Access Compliance Report

Public Rights-of-Way

Intersection ID: 49690	Main Street: ALEXANDER_ALLEY_DR	Cross Street: SHARON_HILLS_RD	Location:	N
ADA ID: 92F690E6F118	Ramp Type: PerpDiag	Initial Pass/Fail: Fail	Overall Compliance: No	Severity Score: 12.5
Codes/Mitigation Info/Possible Solution		Field Measurements/Component Compliance

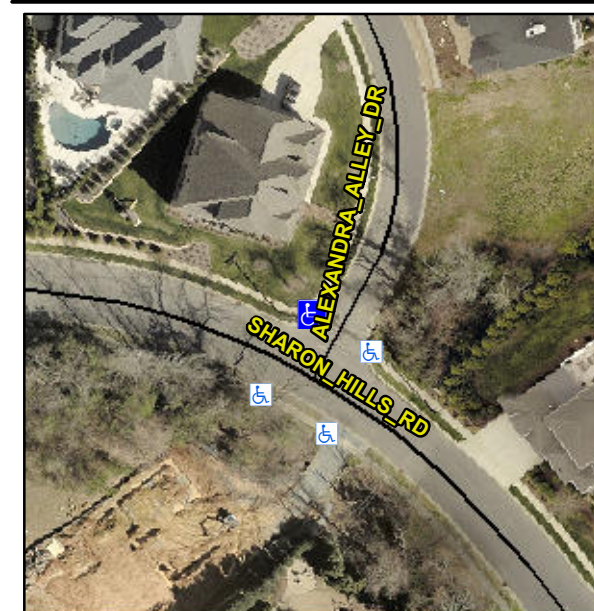
Not Found, R304.2.2

Compliance	Description	Data	Compliance	Description	Data
N/A	Ramp Length (in)	50.0	No	Ramp Slope (%)	9.2
Yes	Ramp Width (in)	48.0	Yes	Ramp XSlope (%)	1.5
N/A	Flare Type LT	N/A	N/A	Flare Type RT	N/A
N/A	Flare Slope LT (%)	N/A	N/A	Flare Slope RT (%)	N/A
N/A	Flare Traversable LT?	N/A	N/A	Flare Traversable RT?	N/A
N/A	Landing Length (in)	N/A	N/A	DWS Provided?	N/A
N/A	Landing Width (in)	N/A	N/A	DWS Contrast?	N/A
N/A	Landing Slope (%)	N/A	N/A	DWS Length (in)	N/A
N/A	Landing X Slope (%)	N/A	N/A	DWS Full Width?	N/A
N/A	Landing Curb? (Y/N)	N/A	N/A	DWS Offset (in)	N/A
N/A	Shared Landing?	N/A			
N/A	Gutter Ponding?	N/A	N/A	Gutter Slope (%)	N/A
N/A	Gutter Lip Ht (in)	N/A	N/A	Gutter X Slope (%)	N/A
N/A	Painted X Walk1?	No	N/A	Painted X Walk2?	No
	X Walk 1 Direction	To SW		X Walk 2 Direction	To SE
N/A	X Walk 1 Width (in)	N/A	N/A	X Walk 2 Width (in)	N/A
	X Walk 1 Slope (%)	0.9		X Walk 2 Slope (%)	1.6
	X Walk 1 X Slope (%)	1.5		X Walk 2 X Slope (%)	0.1

Remove & Replace Curb Ramp With Two New Directional Ramps or Equivalent.
